**CITY OF BOULDER
LANDMARKS BOARD MEETING**

DATE: Wednesday, December 2, 2015

SUBJECT: Public hearing and consideration of a Landmark Alteration Certificate application to demolish an existing house built in 1957 and, in its place, construct a new 2,500 sq. ft. house at 2110 4th Street in the Mapleton Hill Historic District, per section 9-11-18 of the Boulder Revised Code (HIS2015-00254).

Figure 14. Proposed Site Plan

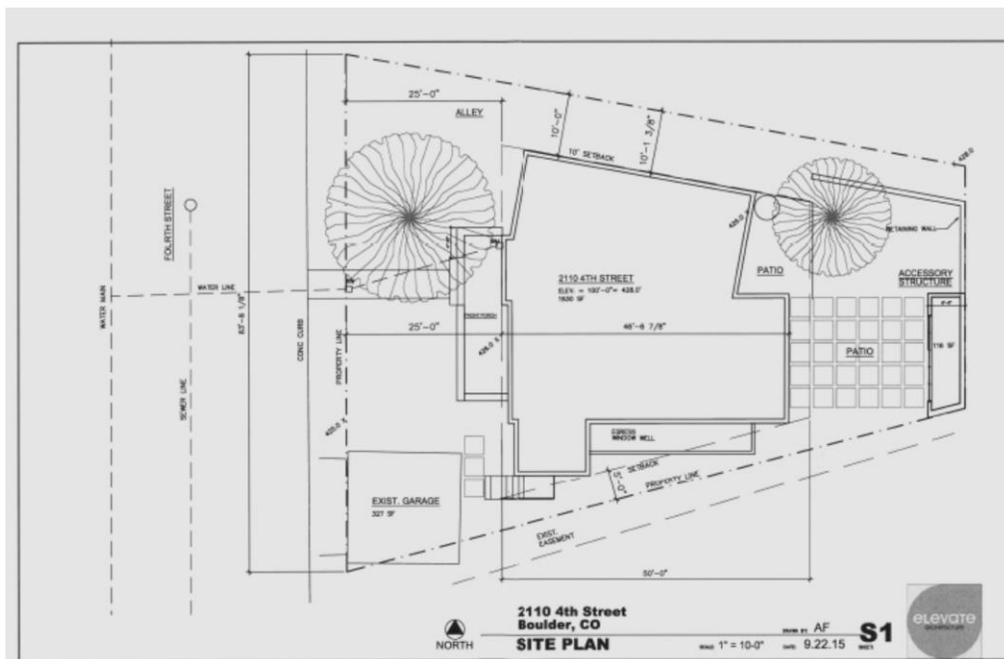
In plan, the proposed new house is shown to be located at approximately the same location as the existing house. The existing house is located approximately 26' from the west property line and the proposed house is shown to be located at the 25' front yard setback. The existing house measures approximately 35' wide and 26' long, with a 21'

by 8' shed-roof portion located at the rear of the house. The proposed house is shown to measure 46'-6" long and approximately 50' wide with the north wall creating an oblique angle running parallel to the north property. Currently the alley provides access to at least one property to the east. The existing contributing garage is shown to be maintained in its current location.

Specifically, the multiple forms, truncated gable tower and oblique building angle at the north will all be highly visible and alter character of the site in a manner that will be incompatible with streetscape and southwest section of Mapleton Hill. The building form should be simplified to reflect the proportion of historic buildings of similar size found in the district. The window proportion, spacing and scale should be revised to reflect traditional patterns found in the district. Similarly, the material palette should be

revised to eliminate the metal roofing and oil copper fascia and proposed traditional roofing material and painted wood siding.

For this reason, staff is recommending denial of the proposal, but suggests that if the Board feels denial is appropriate, that it provide the applicant the opportunity to withdraw the current proposal for redesign, after providing feedback on how they might redesign a house be more consistent with the standards of 9-11-18. Allowing the applicant to withdraw would prevent the applicant from waiting a year to reapply per 9-11-17(C), B.R.C. 1981.

Proposed East and West Elevations

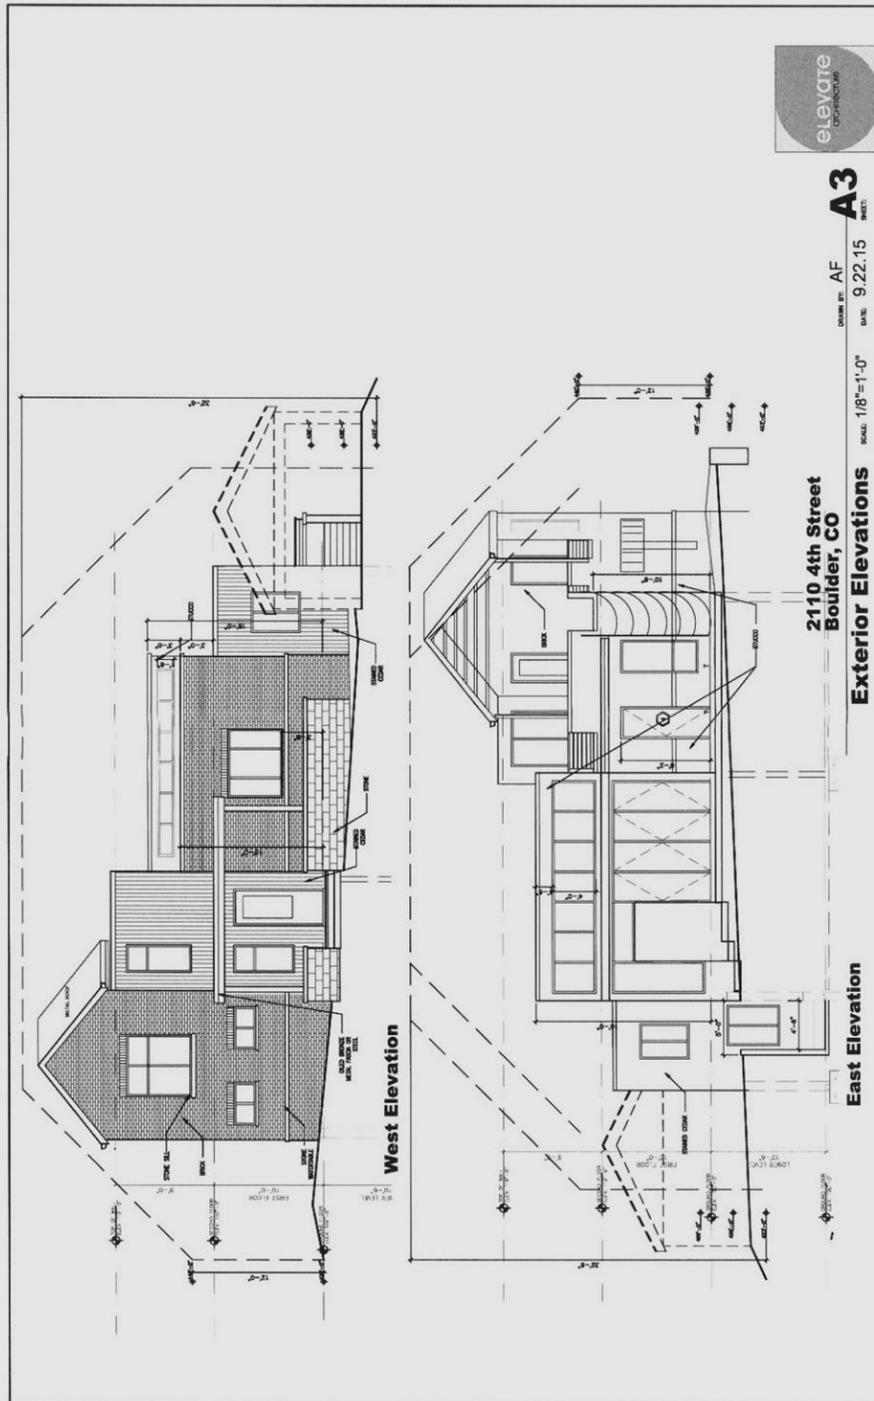
Elevations indicate the house to be of frame construction, with a single gable and three flat roof forms. At its highest point the house is shown to be approximately 30' above grade, with flat roof forms stepping down to the south.

Drawings and renderings show the façade to feature three building forms: a vertical, front-gable portion at the north that is clad in brick, a two-story rectangular form with a flat-roof porch over the entrance, a cubic volume clad in brick, and a lower, flat roof
